# Norwich to Tilbury

Document: 7.22 2025 - Design Development Report Addendum for  
Proposed Changes to Connection at Tilbury

Addendum for Proposed Changes to Connection at Tilbury

AENC-NG-CNS-REP-0165

**Figure 2 - Plan showing the proposed amended change of connection at Tilbury**

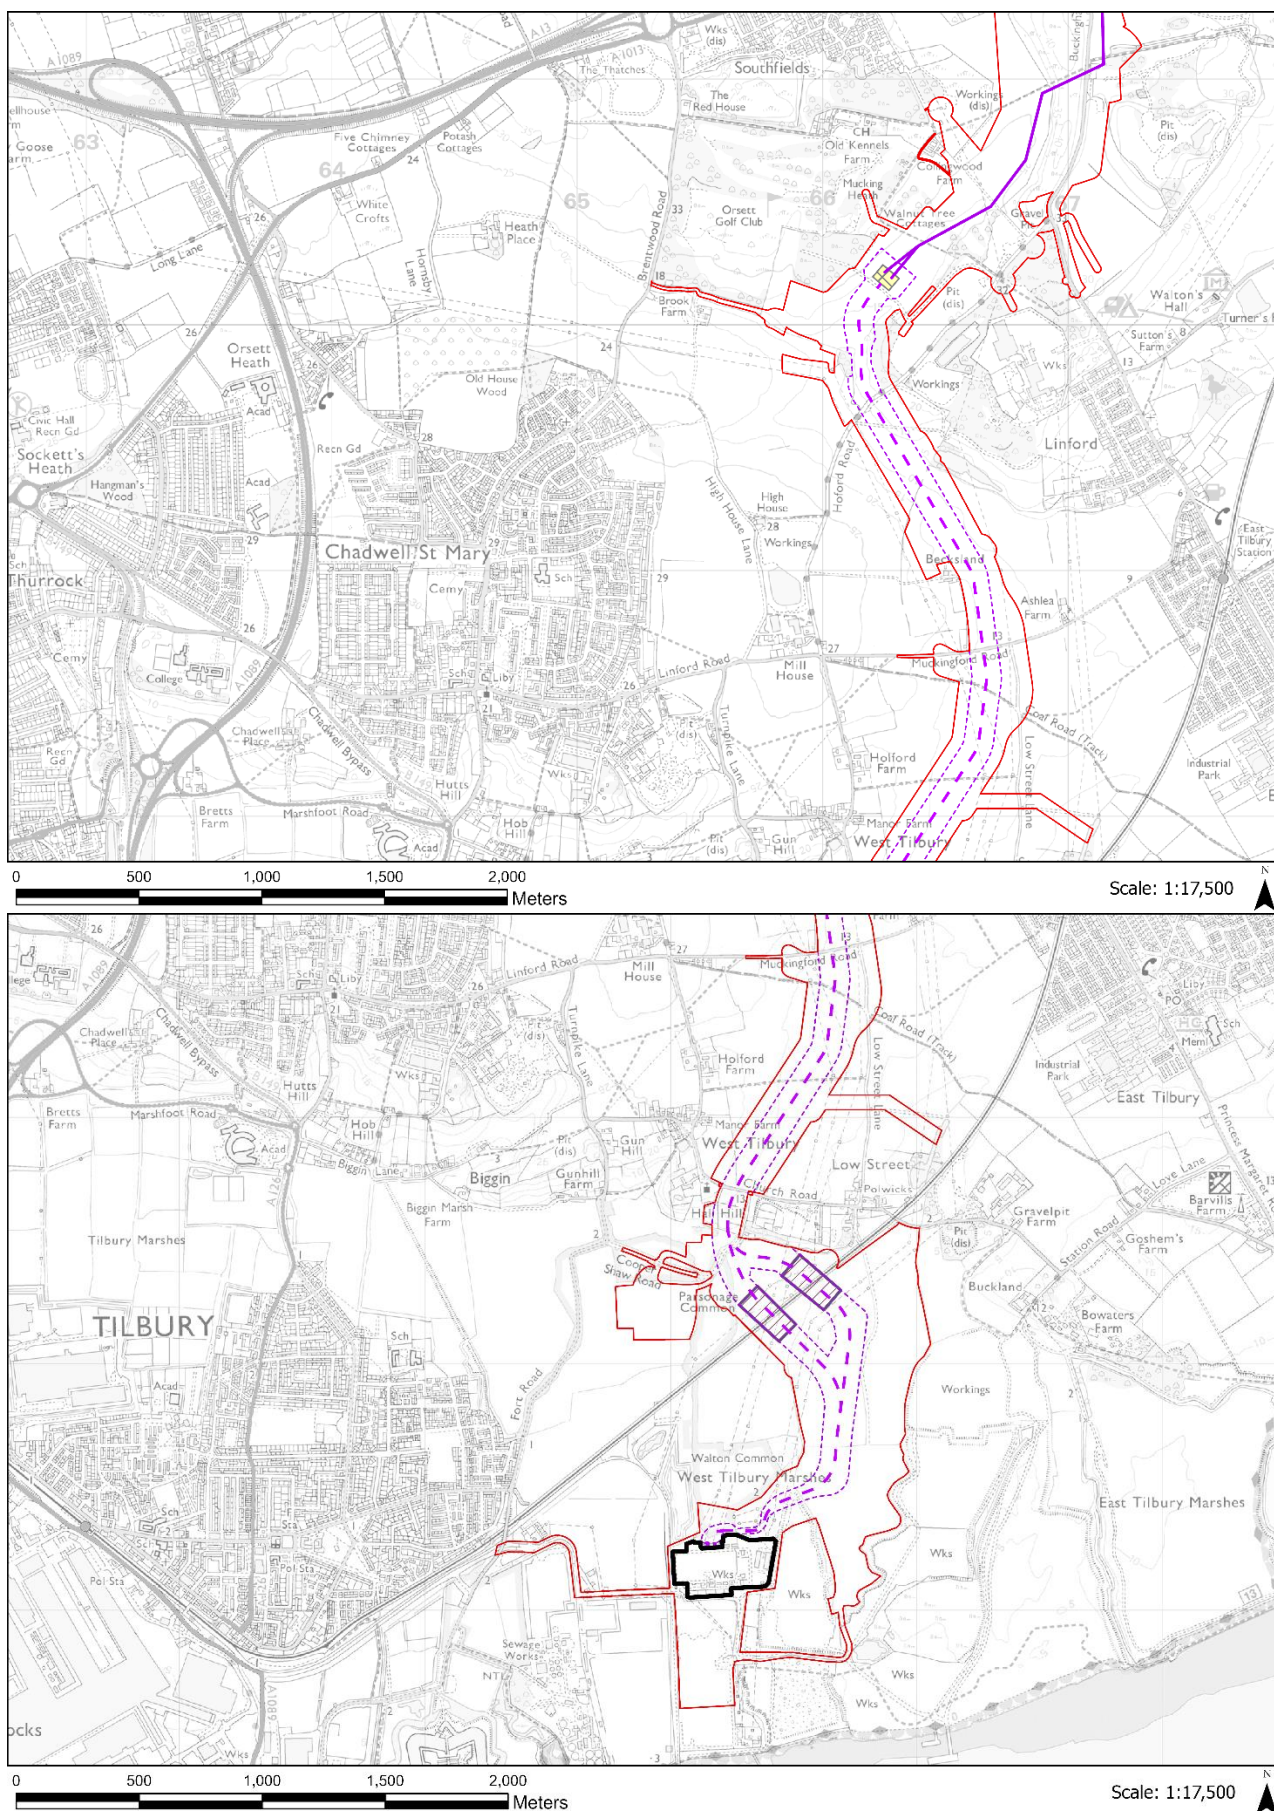
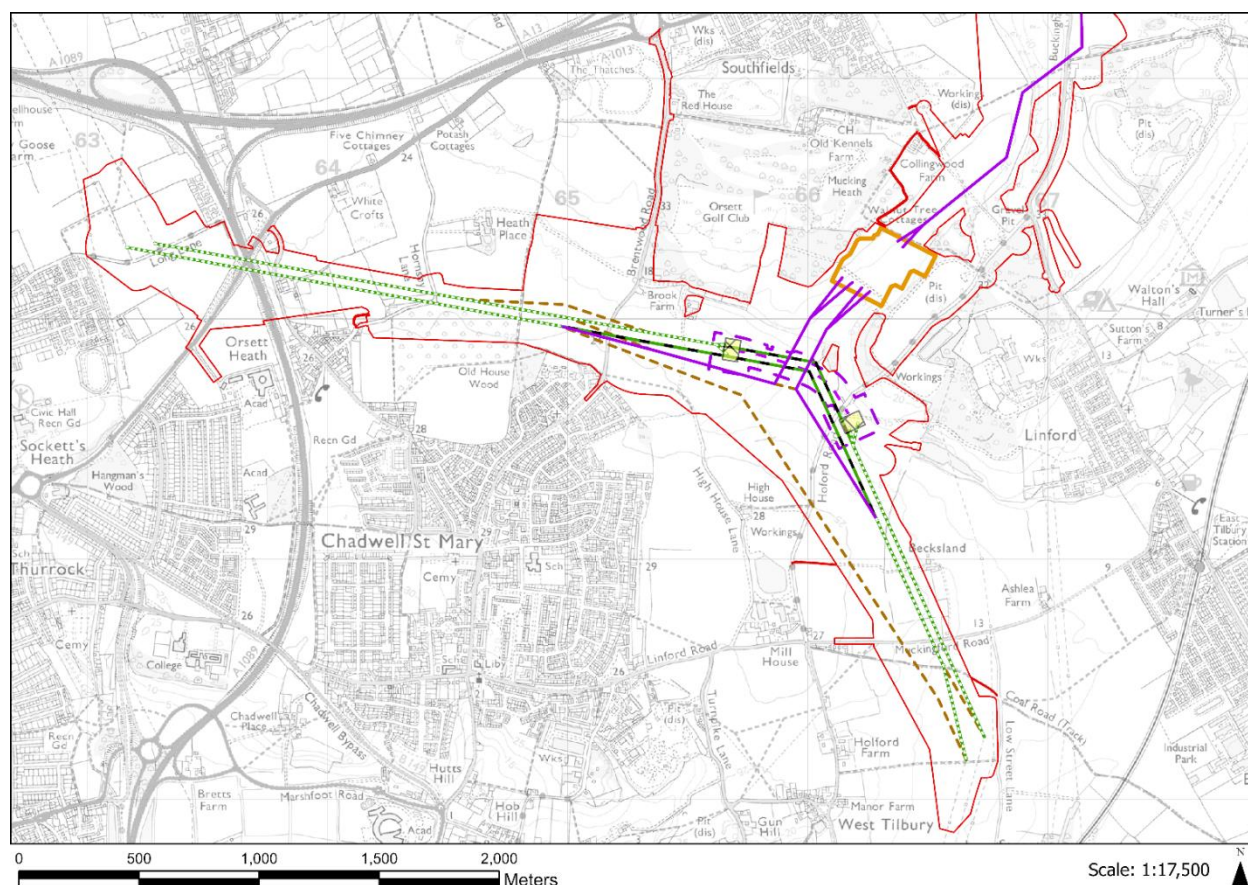
- 1.2.5 Plans showing the general arrangements of the connection into Tilbury at statutory consultation are shown below (Figure 1). A summary of the main changes follows (Figure 2).

1.2.6 The main changes proposed are as follows:

- Change to the Connection arrangement for the Norwich to Tilbury Project, changing it from the installation of a cable sealing end compound and new cable connection to Tilbury Substation to a new substation and connection into, and use of, the existing overhead lines to the south of Orsett golf course to achieve the connection to Tilbury Substation. Change associated with:
  - change to proposed Order Limits including flexibility to reduce potential effects if Lower Thames Crossing project delayed or cancelled
- Removal from the Project of:

1.2.7 a CSE compound to the south of Orsett golf course

- 4.5 km of underground cable from the CSE south of Orsett golf course to Tilbury Substation
- Any remaining interaction and potential restriction to key economic growth centres at Port of Tilbury and Freeport amongst others
- Addition to the Project of:
  - a new substation referred to as Tilbury North to the south of Orsett golf course on the location of the removed CSE
  - Two CSEs to underground around 600m of the more easterly of the existing overhead lines

- Diversions to the south (by up to 100m) of the more westerly of the existing overhead lines along with new overhead line to connect to Tilbury North Substation
- Replacement of around 600m of the ZB overhead line with underground cable requiring two CSEs.
- Modification to the existing network for the purposes of connecting electrically into the existing Tilbury Substation:
  - the location of the overhead line crossing of Orsett golf course.
  - The arrangements to cross the proposed Lower Thames Crossing project from underground cable to overhead line
- Temporary use of land:
  - for temporary diversions of overhead line to maintain connections
  - to facilitate installation work e.g. green lines for re-stringing with no change to permanent assets
  - for construction access arrangements

**Figure 3 – Tilbury North Substation Options**

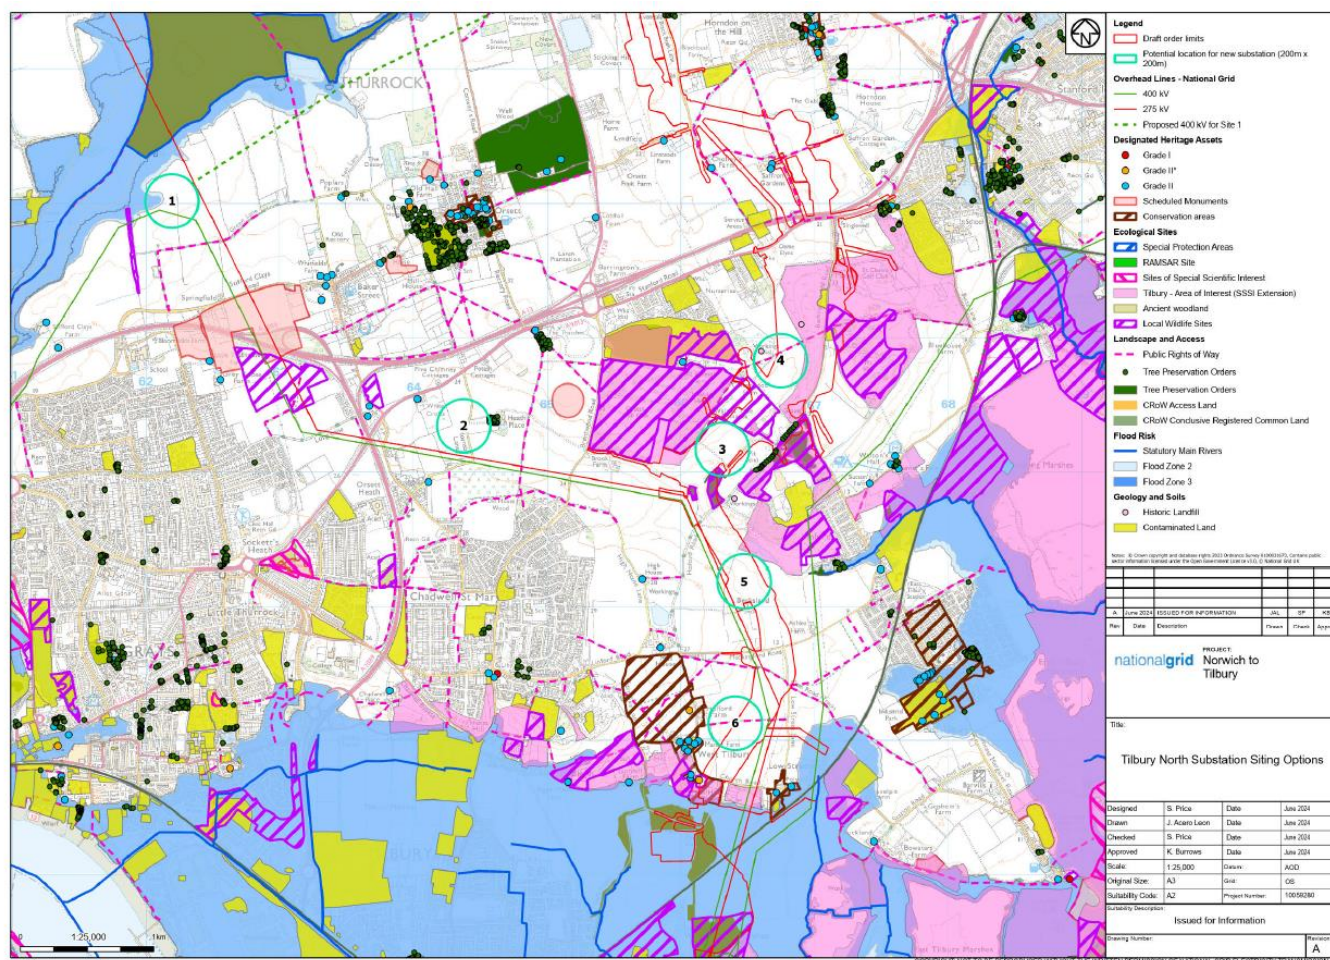
- 1.3.14 Locations both to the north-west (up to where the existing YYJ and ZB overhead lines diverge just north of the A13), to the south (through to Tilbury Substation) or to the north along the Norwich to Tilbury Project alignment were identified and considered. Indicative locations are shown on the image below (shown as numbered in turquoise coloured circles):

- 1.3.16 On this basis, Site 1 is scoped out of further consideration as the need to acquire survey data on various environmental and technical topics to inform design and necessary environmental assessment leads to an expected programme delay estimated to be in the order of 2 years, leading to an in service date beyond 2030 that would trigger high constraint cost payments. This fails to meet the minimum need case requirement and therefore Site 1 is not progressed.

- 1.3.17 Site 2 has major transport infrastructure to the north and potentially LTC to the west. The location has residential properties, listed buildings and scheduled monuments (near to Heath Place) to all sides. With any overhead line connection routes also having insufficient spacing between residential properties. These constraints alone may scope this site out as a preferred option but even if less constrained this site would, like Site 1, be scoped out because of the additional

- 1.3.18 All other sites are considered capable of meeting the need case requirement, but are also subject to benefit filter review.
- 1.3.19 Site 4 is assessed to lead to extra effects and costs compared with Site 3. These are expected to include similar effects on the housing allocation at Chadwell St Mary due to similar diversion requirements of the YYJ and ZB, but with additional effects, affecting a similar area of potential housing, on the Southfields opportunity area. The crossing of Orsett golf course would increase effects as a result of the crossing by two overhead lines. For these reasons Site 4 performs less well than Site 3 so Site 4 is not taken forwards.

- 1.3.20 Site 6, whilst potentially providing an alternative to Site 5, requires the additional cost of longer cables to reach the site including the additional complexity of an additional trenchless crossing under Muckingford Road. It potentially avoids effects on housing at Chadwell St Mary though does route through an area that may provide green space for that development. It is also considered to be a less economic solution than Site 5.

- 1.3.21 Following the above site identification and initial down-selection review, Sites 3 and 5 were taken forward for more detailed consideration.

- 1.3.22 The preferred Tilbury North Substation location is at Site 3. It presents some different technical risks due to the need for system outages, but these are within the scope of normal system management risks. In cost terms, compared with the design published in the 2024 statutory consultation, this change is expected to be broadly cost neutral. However, there is some uncertainty on such comparisons regarding the costs associated with securing necessary rights through the Freeport area (influencing the base case of the 2024 statutory consultation proposals) and Chadwell St Mary housing area if allocated (influencing the Site 3 costs). Additionally, the proposal does have technical benefit by virtue of the substation works being a substantially off-line build (unlike the 2024 statutory consultation proposals which are within an existing substation and requiring some decommission of operational assets) and overall presents less technical risk to delivery and to programme.

- 1.3.29 In conclusion, the preferred site for the proposed Tilbury North Substation is Site 3. This avoids the interactions around Tilbury Port, Freeport and their environs. It does however have potential to reduce the area potentially available for housing (as a result of how the connection to the YYJ line would need to be made) on land to the east of Chadwell St Mary being consulted upon for potential allocation in the local plan. Due to the layout of existing overhead lines, the ZB line (275kV) needs to be replaced, in part, by a short section of cable between new cable sealing end compounds. In the case of LTC progressing to construction, the space required for the CSE compounds, along with the constraints of the works associated with Lower Thames Crossing, will require a section of the YYJ to be diverted to the south and west deviating by up to approximately 100m from the existing YYJ alignment. The scale of interface may potentially reduce the development area by up to 8 hectares (within an estimated total allocation area of up to around 90 hectares) though this extent will only be confirmed once detailed design is completed and a reduced extent may well be achieved within Limits of Deviation. Even then it is anticipated that site masterplanning would further reduce the loss of housing land by repositioning of some land uses.
